SOLICITATION NO. W911WN-04-R-0003

CHARLEROI LOCKS, CONTRACT 1
CHARLEROI LOCKS AND DAM
MONONGAHELA RIVER, PENNSYLVANIA

NUMBER 5

The following changes are made to the Request for Proposal for Charleroi Locks, Contract 1, Charleroi Locks and Dam, Monongahela River, Pennsylvania:

MONONGAHELA RIVER
CHARLEROI LOCKS AND DAM
LOCKS - CONTRACT #1
RIVER WALL
MONOLITHS R-29 AND R-30
PRECAST CULVERT REINFORCEMENT

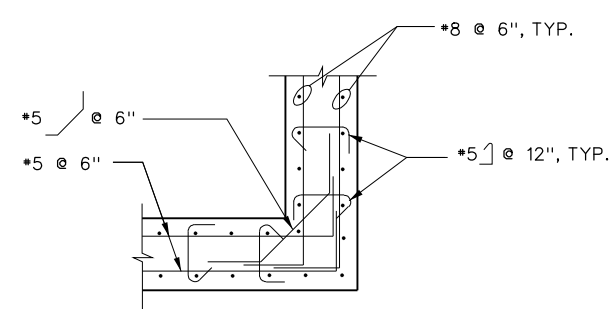
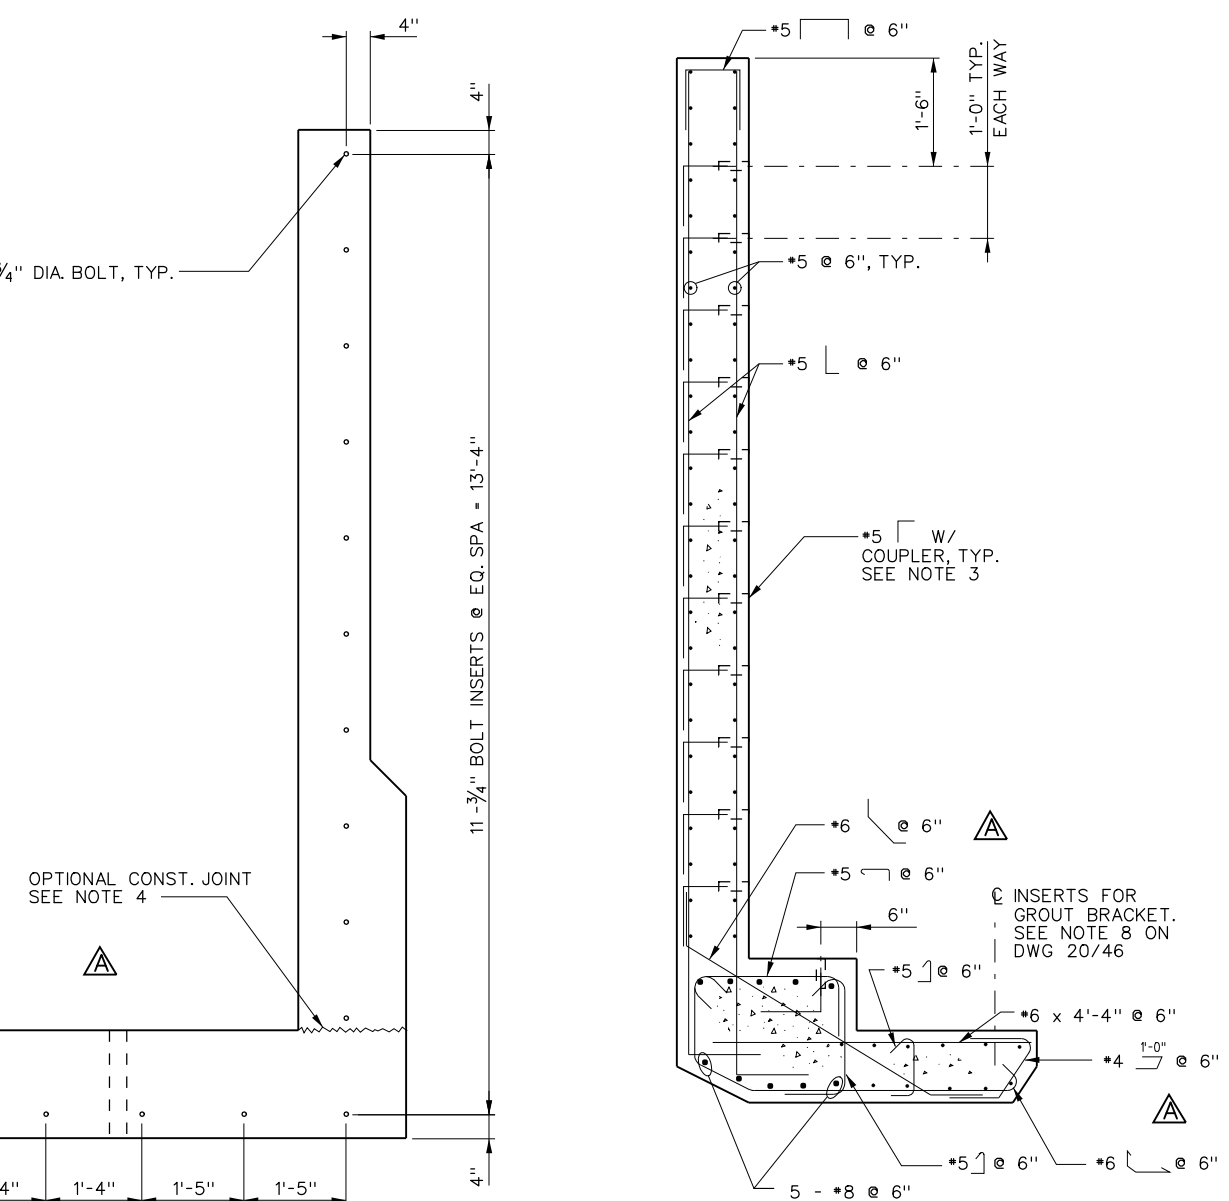
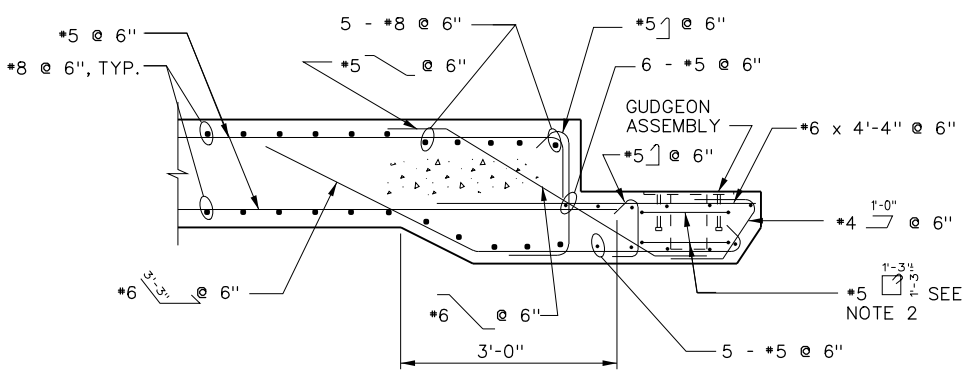
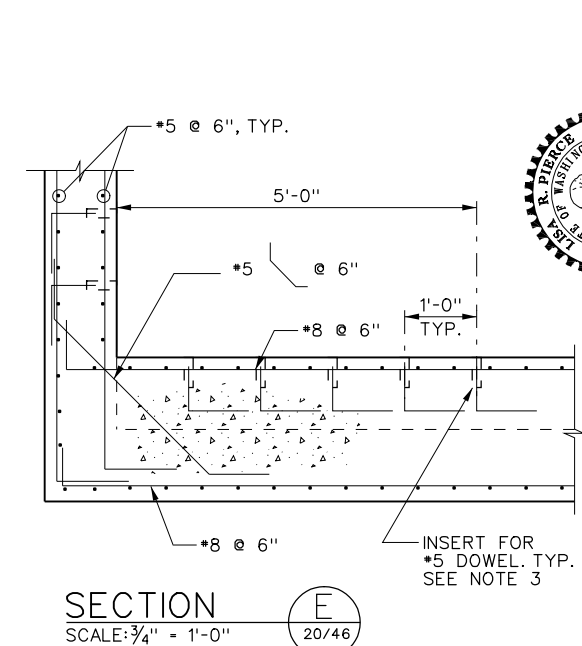
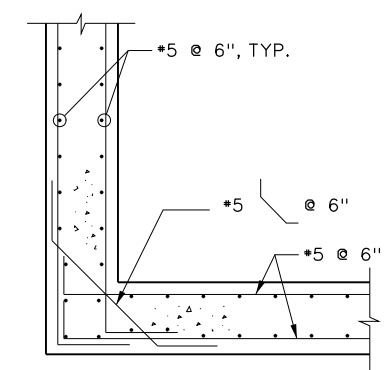
Symbols	Description	Date	Appr.
A	REV TO ADD BOT. CHAMFER - AMEND. NO. 5	17 JUN 04	MJ
F:	M-Char Lock-CIN sheet\AM5\NCA\2004\8a-s-5 s01

MONONGAHELA RIVER
CHARLEROI LOCKS AND DAM
LOCKS - CONTRACT #1
RIVER WALL
MONOLITHS R-29 AND R-30
SECTION PLAN AND DETAILS

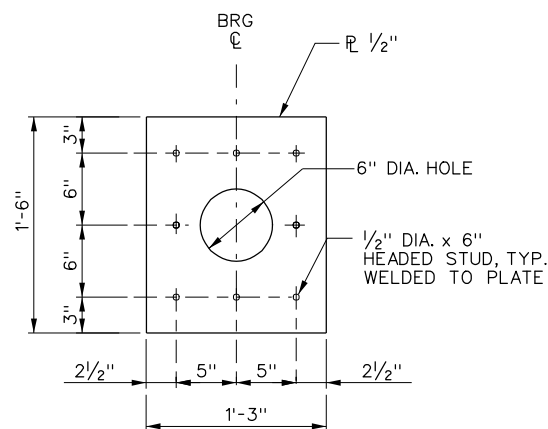
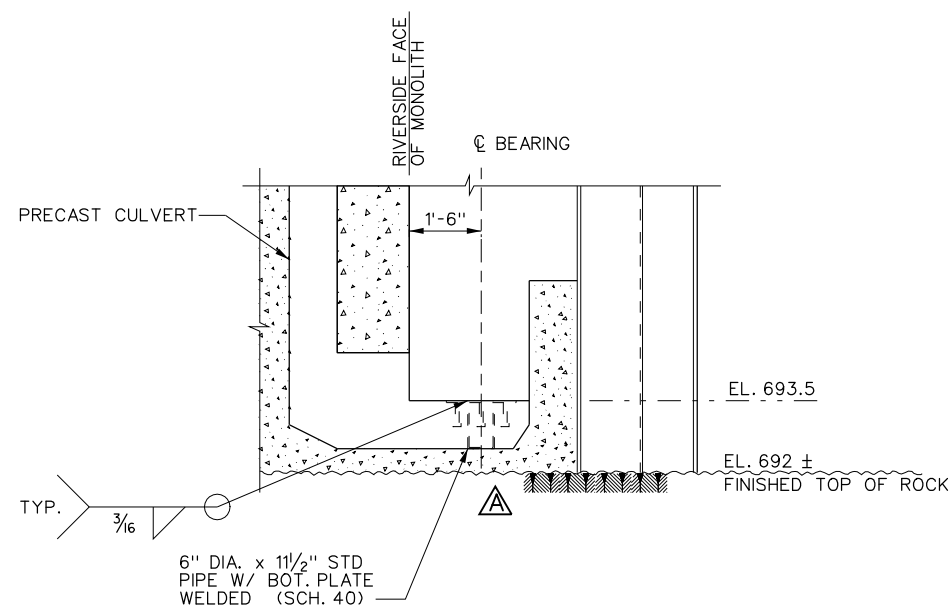
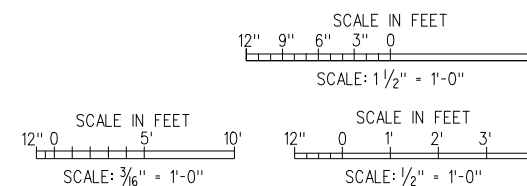
Symbol	Description	Date	Appr.
A	REV. TO ADD BOT. CHAMFER - AMEND. NO. 5	17 JUN 04	M

MONONGAHELA RIVER
CHARLEROI LOCKS AND DAM
LOCKS - CONTRACT #1
RIVER WALL
MONOLITHS R-29 AND R-30
REINFORCING DETAILS

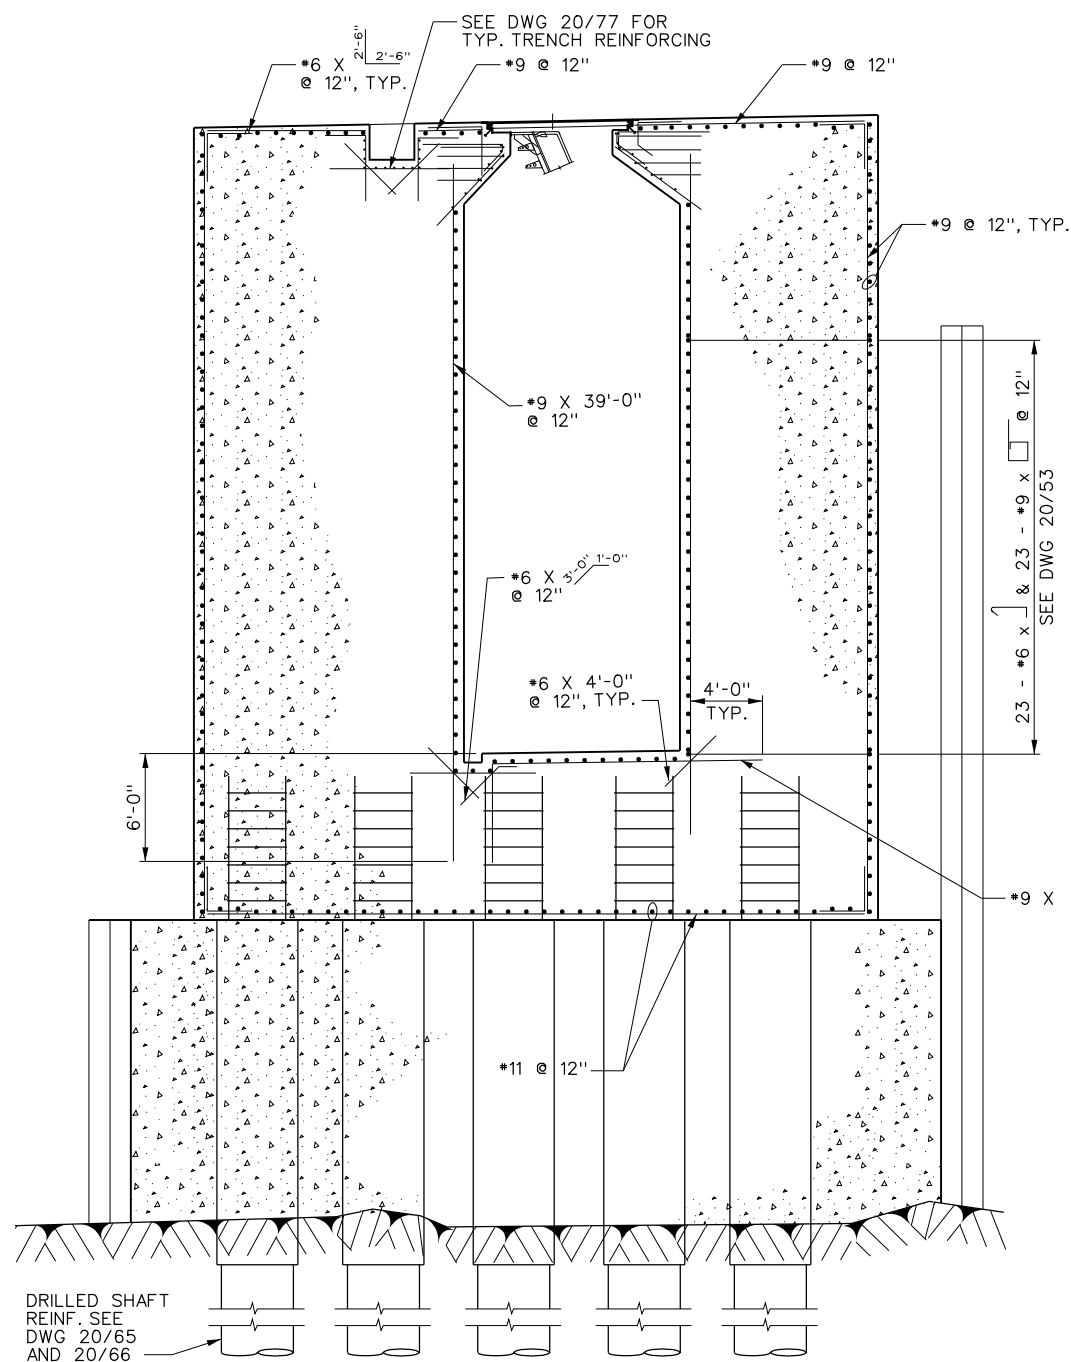
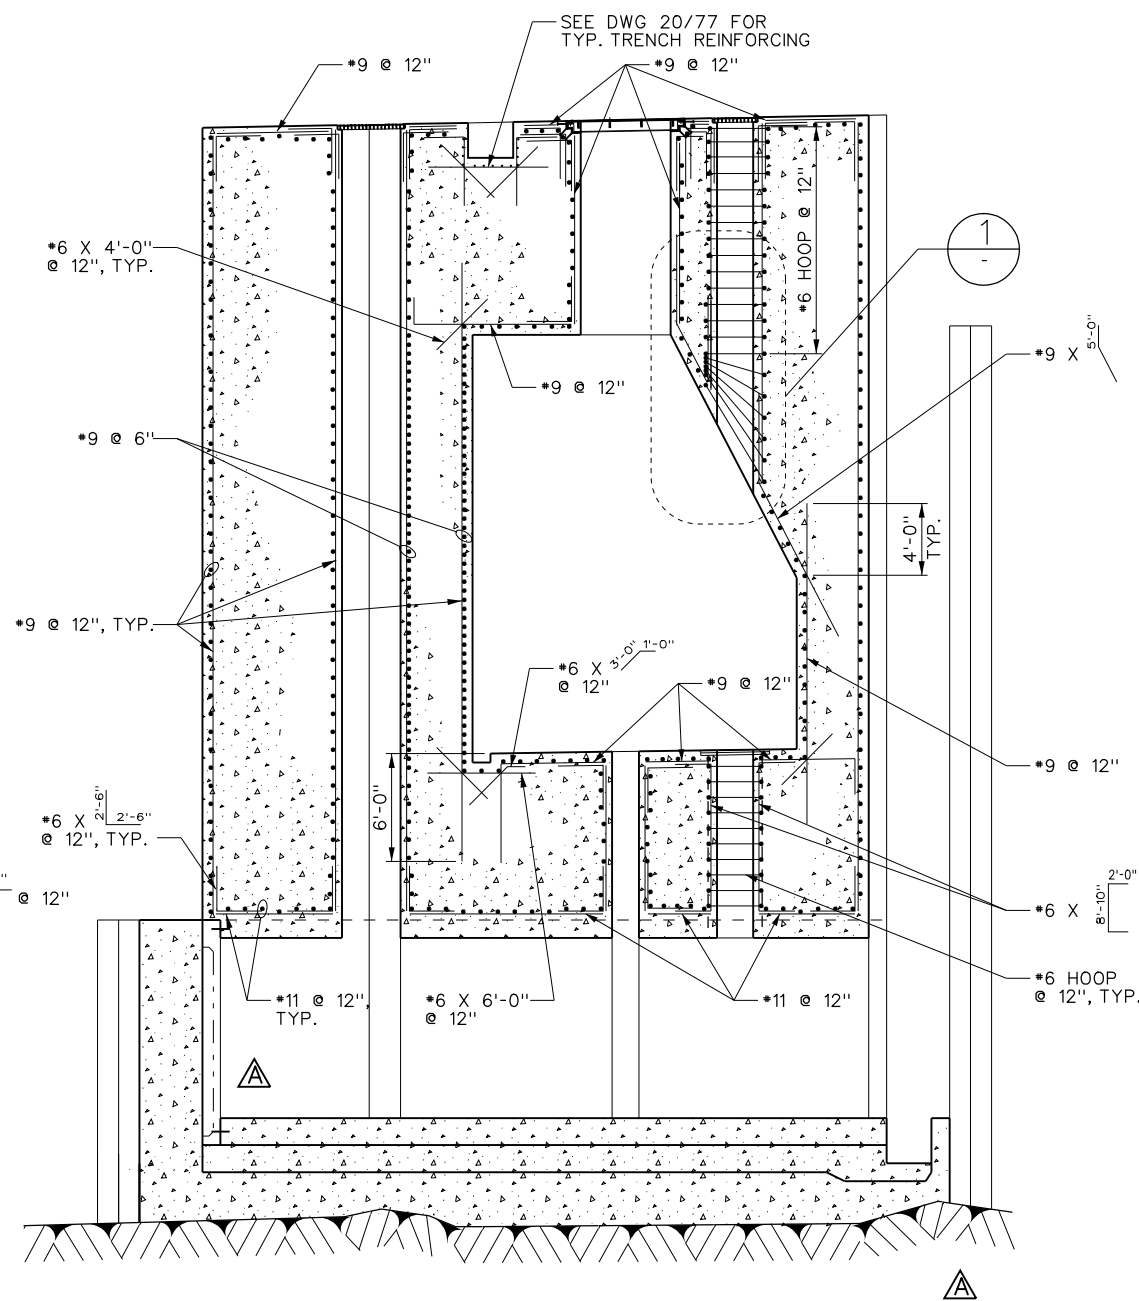
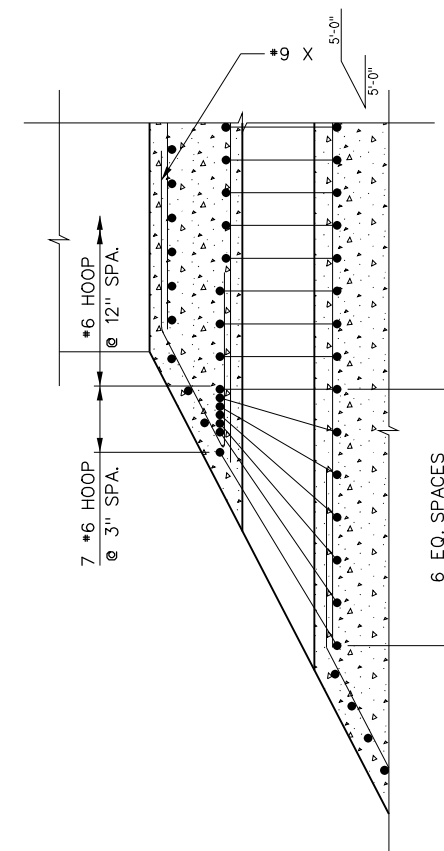
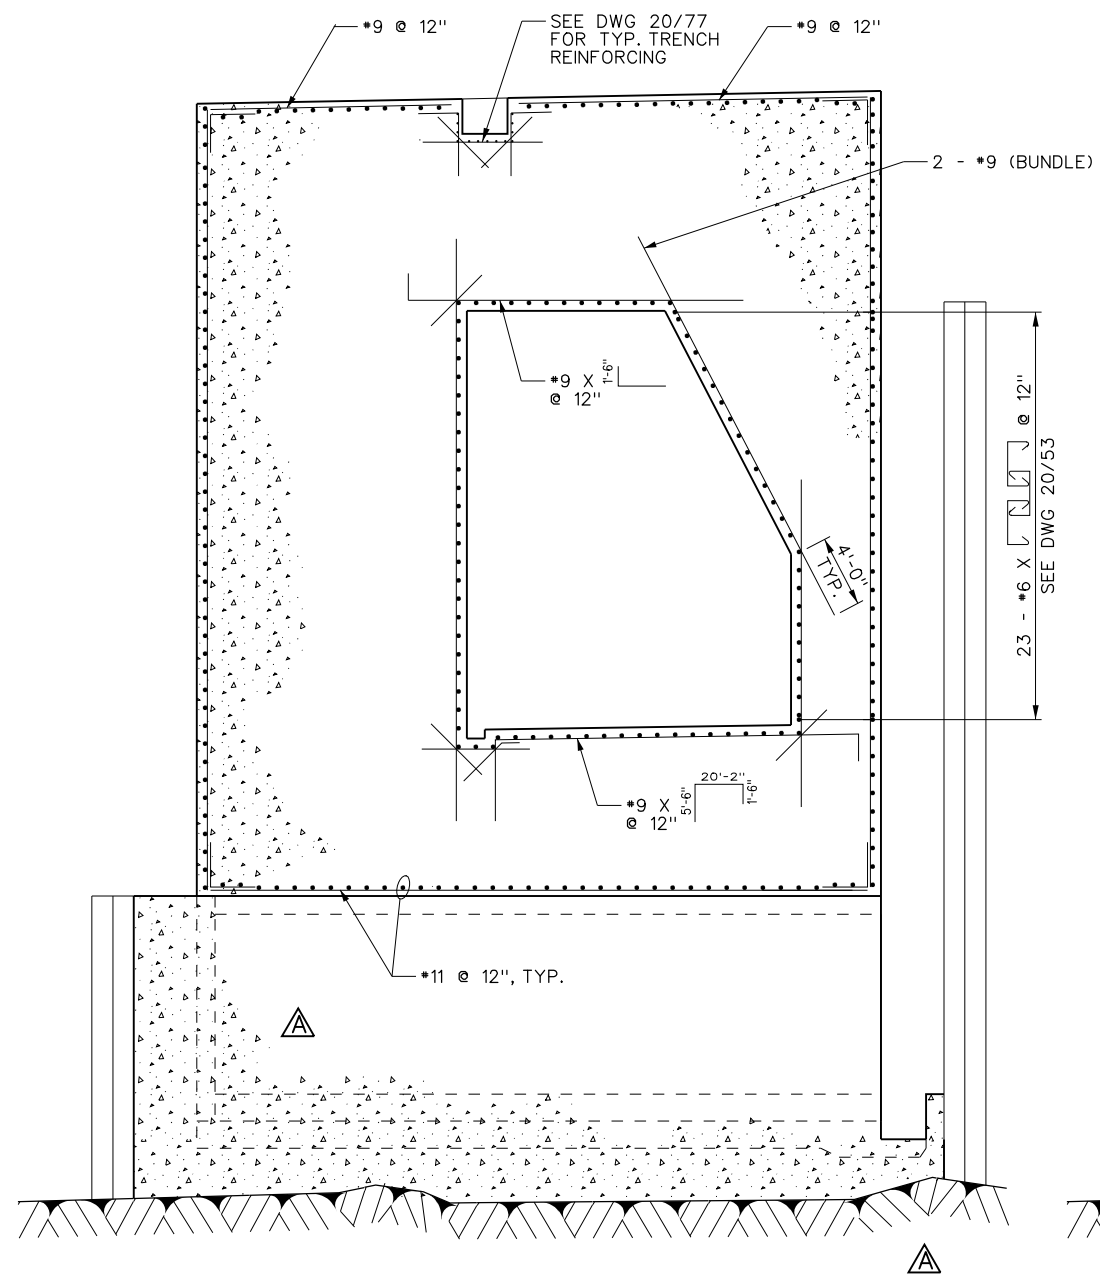
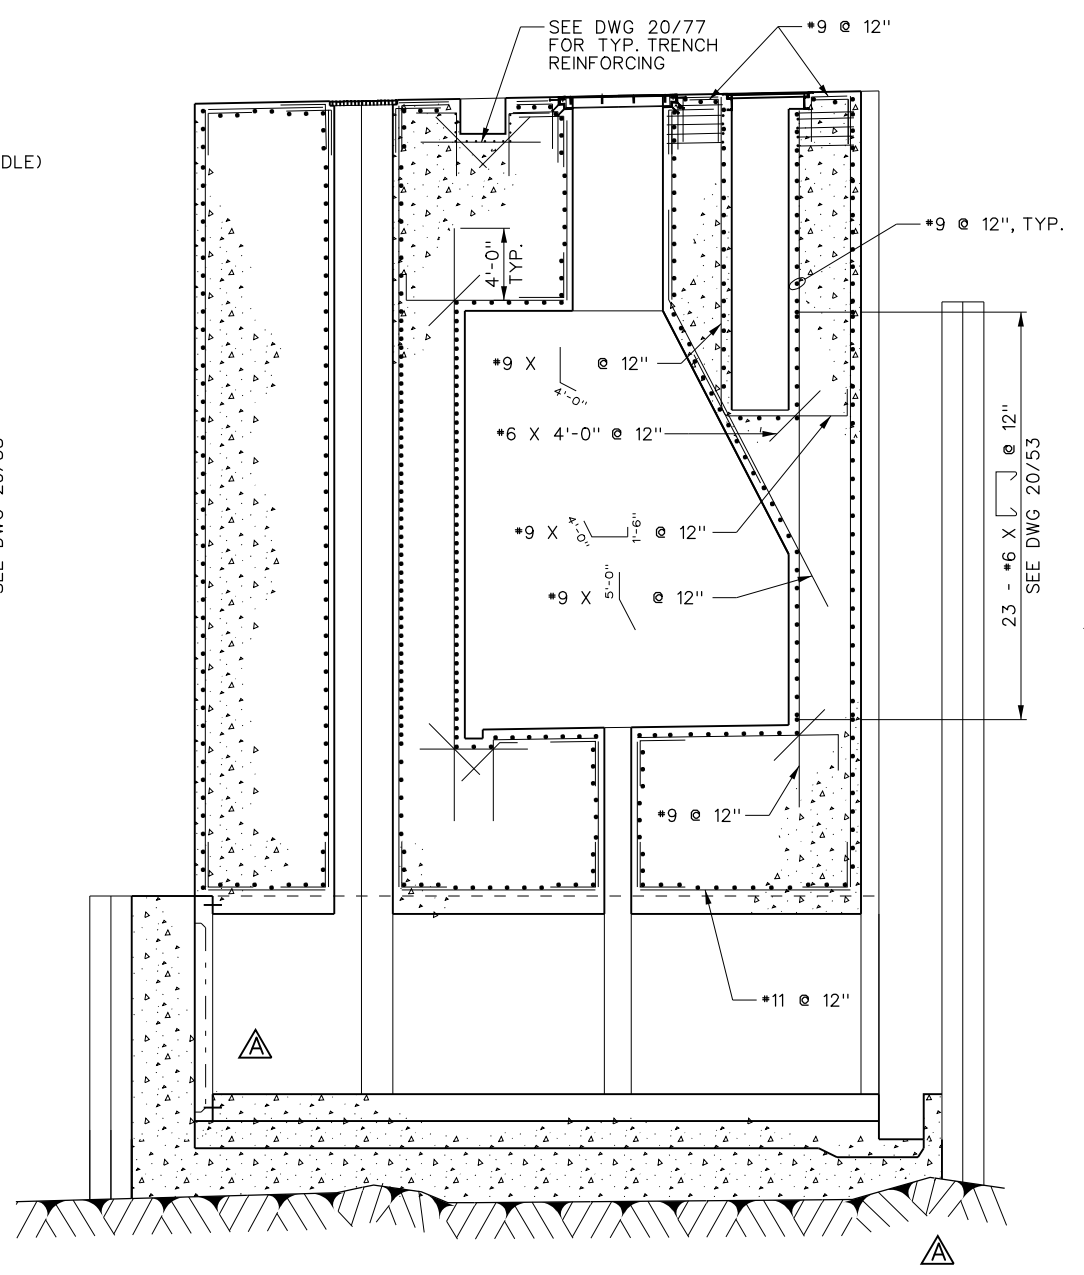
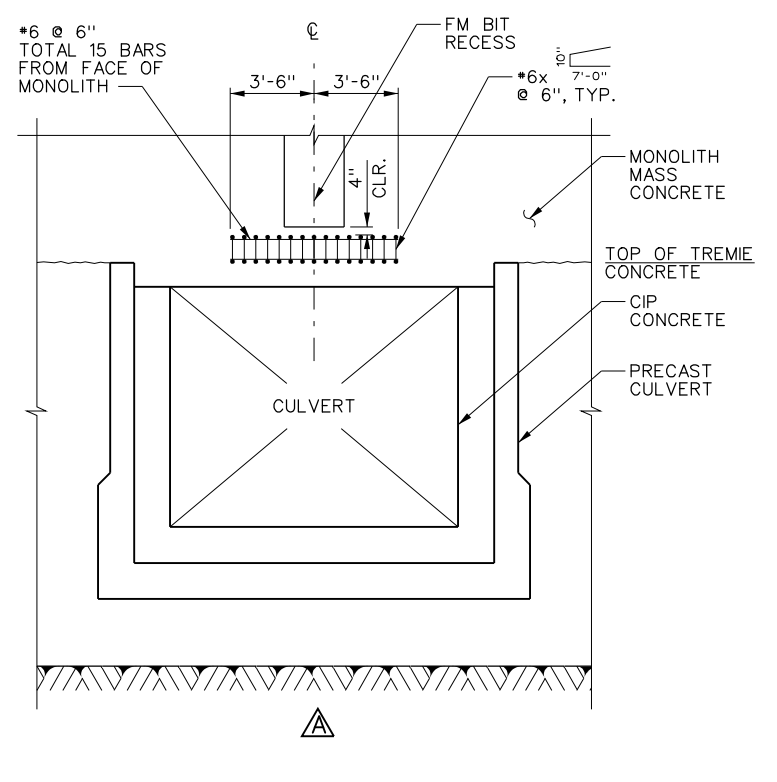
Symbol	Description	Date	Appr.
A	DELETE FILLET & ADD CHAMFER - AMEND. NO. 5	17 JUN 04	LRP
F:\M-Chor Lock-C1\sheet\AM5\NINCA\20055a-s-5.s01

MONONGAHELA RIVER
CHARLEOILLOCKS AND DAM
LOCKS - CONTRACT #1
RIVER WALL
DRILLED SHAFT LOCATION
COORDINATES

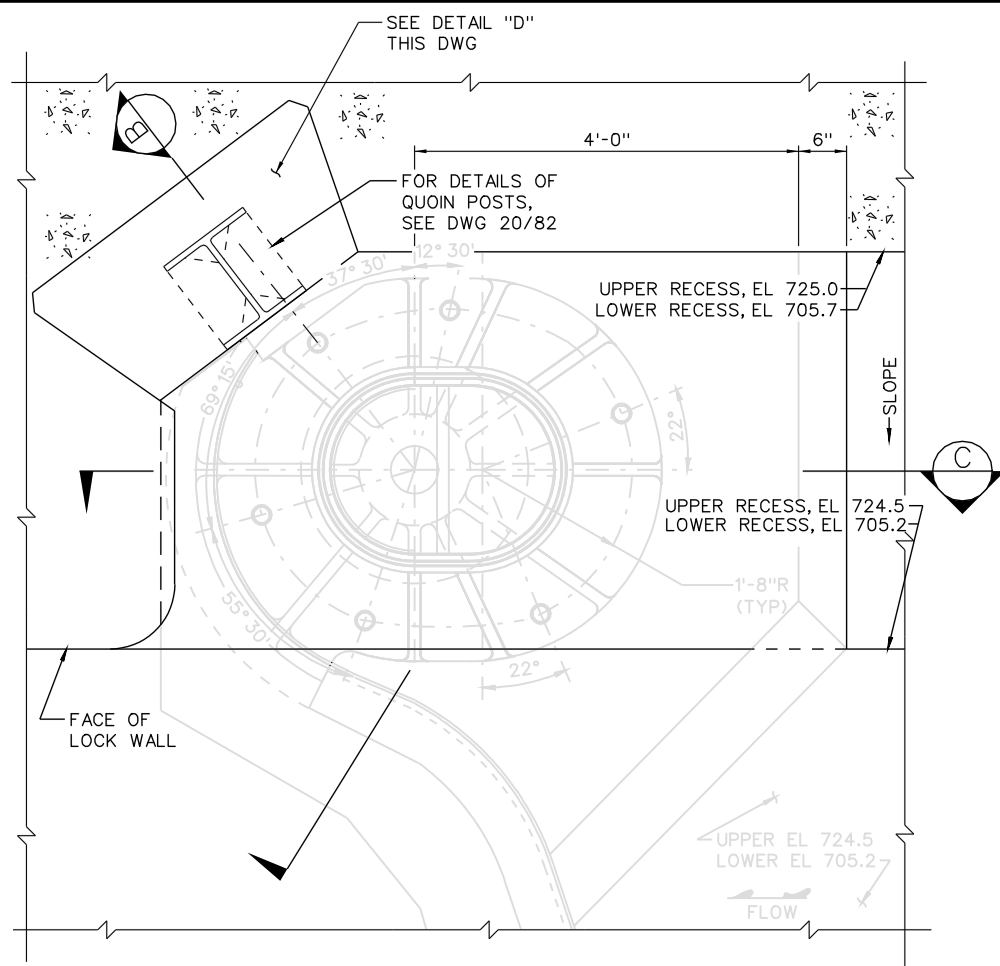
Symbol	Description	Date	Appr:
A	DRILLED SHAFT R-15-6 DATA INSERTED - AMEND NO. 5 E:\M.Chahal\ask-CIN\sheet\MEX200561ns-5-6.rvt	16 JUN 04	RAA
